PECO ENERGY

SUBJECT: Peach Bottom Atomic Power Station, Units 2 and 3
Facility Operating License Change Request 93-18

The proposed changes are necessary to support PBAPS Modification P00271, which will replace the Source Range and Intermediate Range Monitors with a new Wide Range Neutron Monitoring System (WRNMS).

Figure 3.3.1.2-1 (page 1 of 1)
Minimum ~~SRM~~ Count Rate Versus Signal to Noise Ratio
WRNM

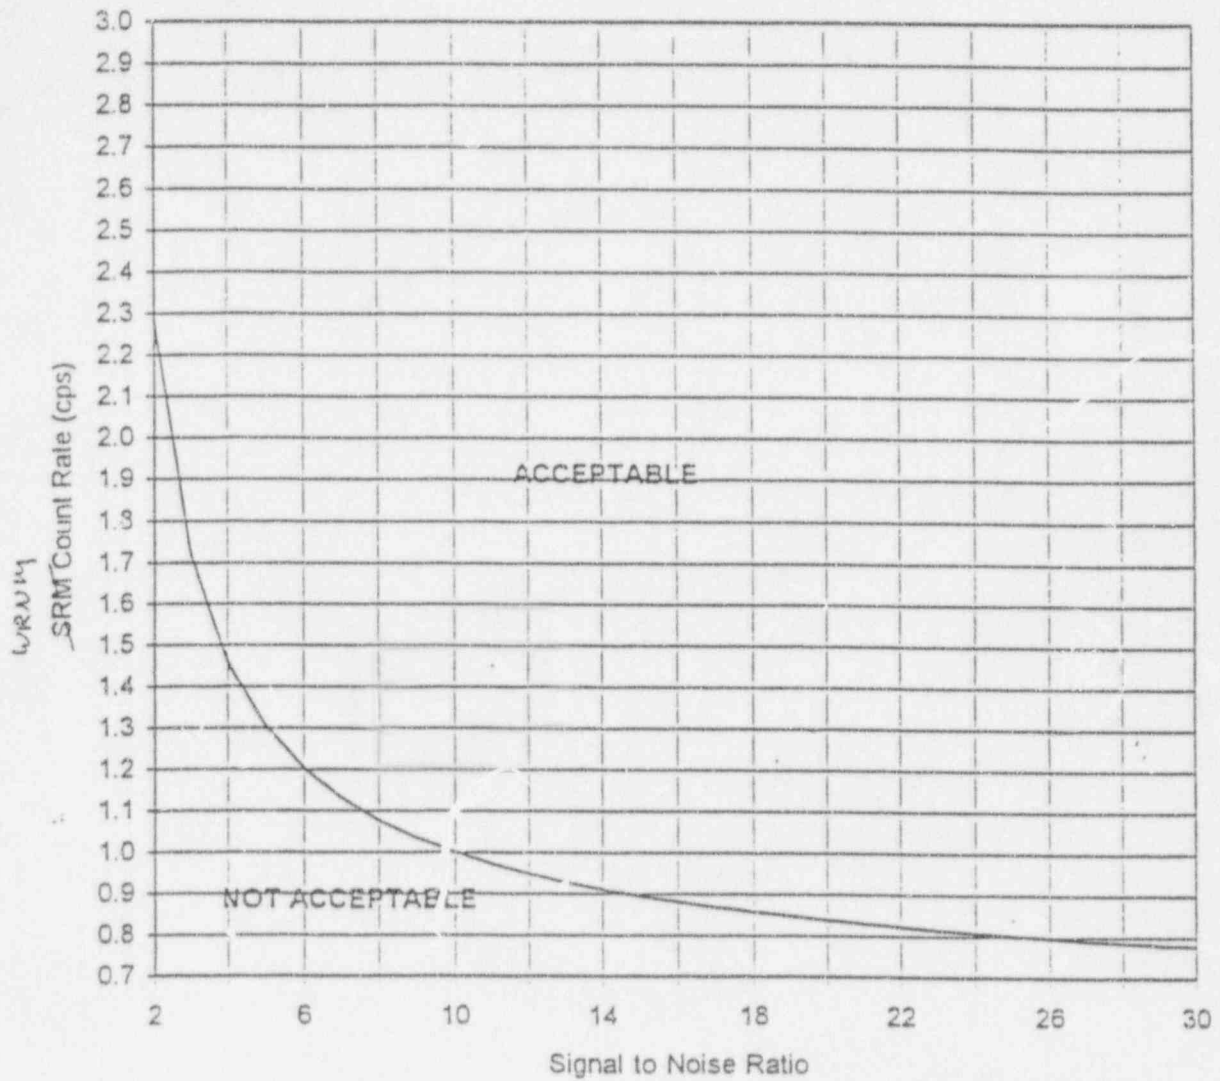
3.3-15	Figure 3.3.1.2-1	Change SRM to WRNM.
3.6-23	Spec. 3.6.2.1	Change all 4 (3 in LCO and 1 in ACTION A.) indicated values to reflect WRNM.
3.6-24	CONDITIONS, ACTIONS	Change indicated values in B.1 and C. to reflect WRNM.
B3.2-3	B3.2.1 APPLICABILITY	Change intermediate range monitor to WRNM.
B3.2-8	P 3.2.2 APPLICABILITY	Change reference from IRM to wide range neutron monitor period-short function.
B3.3-5 & 6	B 3.3.1.1 Neutron Period-Short	In Item 1.a, change the titles, and add new text to reflect design change from IRM to the WRNMS, describe the new period measurement and trip functions, and replace Ref. 2 and 3 with just Ref. 3. Replace paragraph addressing "limiting other reactivity excursions" with the equivalent paragraph based on NUREG-1433, and changing IRM to WRNM.
B3.3-6 & 7	B 3.3.1.1 WRNM-Inop.	Item 1.b. change title and description to reflect design change from IRM to the WRNMS.
B3.3-7	B 3.3.1.1 APRM Flux-High	Item 2.a. description changed to reflect design change from IRM to the WRNMS.
